Chain tensioner

febi no. 21275

fits BMW E87 116i with N45 115 PS / 85 KW engines

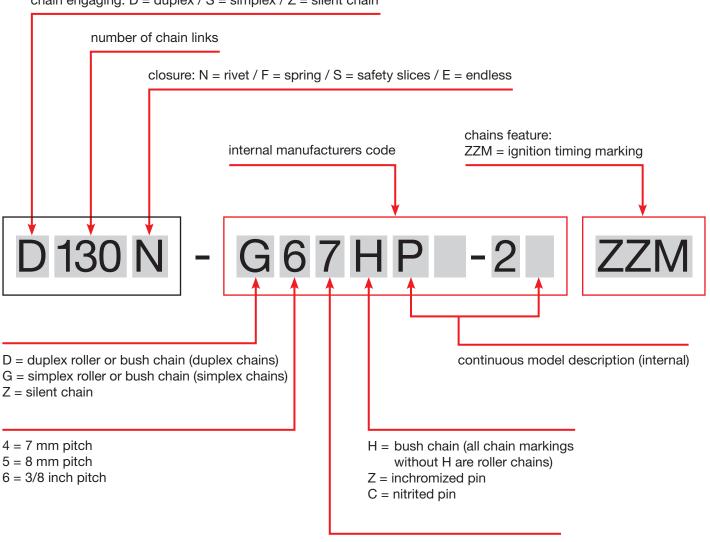
The timing chain jumps even though all the components are properly fitted. Jumping of the chain can cause the engine to run unevenly and can even lead to engine damage.

The original version (repl. No 11 31 1 439 851) of the chain tensioner has a larger hole above the thread (see Fig. 1). The car manufacturer fitted this version of the chain tensioner in the vehicles referred to above. The result is that the chain can jump under unfavourable loads. In the worst case, valves and pistons come into contact with each other - resulting in engine damage. This version has been replaced by the car manufacturer and is no longer in use.

febi recommends using only current chain tensioner febi 21275 (repl. no. 11 31 7 567 680). This chain tensioner has a small hole below the head (see Fig. 2). Consequently, these ensure perfect guidance of the chain under all conditions and prevent jumping.

The previous design of the chain tensioner is still frequently being offered on the market. The new design is also on sale but does not include the necessary seal ring!
